GENT by Honeywell

# Technical Bulletin

TB 10221 | July 2017

Commissioning tool v1.33 & back compatible sounder issue.

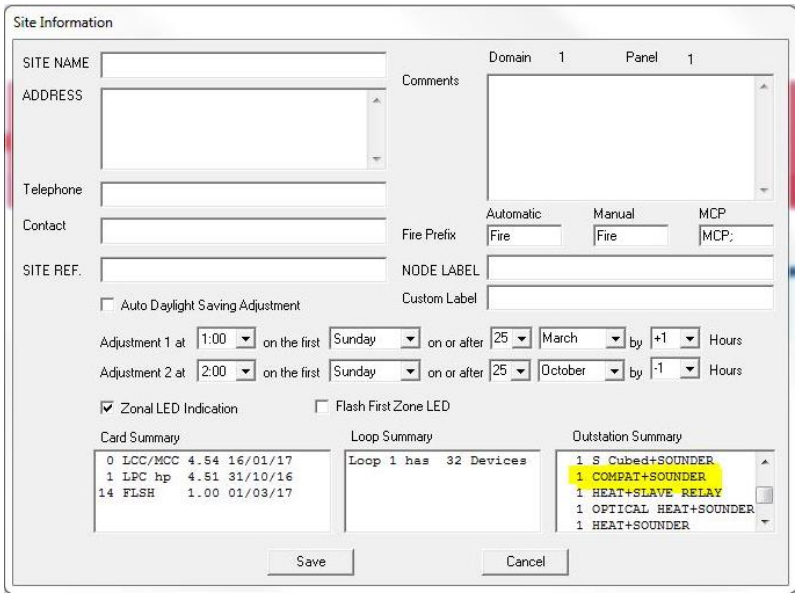
If you open up the Site configuration file, then the Site information screen. Bottom right shows a summary of devices on that system. Check for “Compat+sounder”

If any of these devices are found on sites where commissioning tool v1.33 has been used, please ensure that the volume of the back compatible sounders is correctly set.
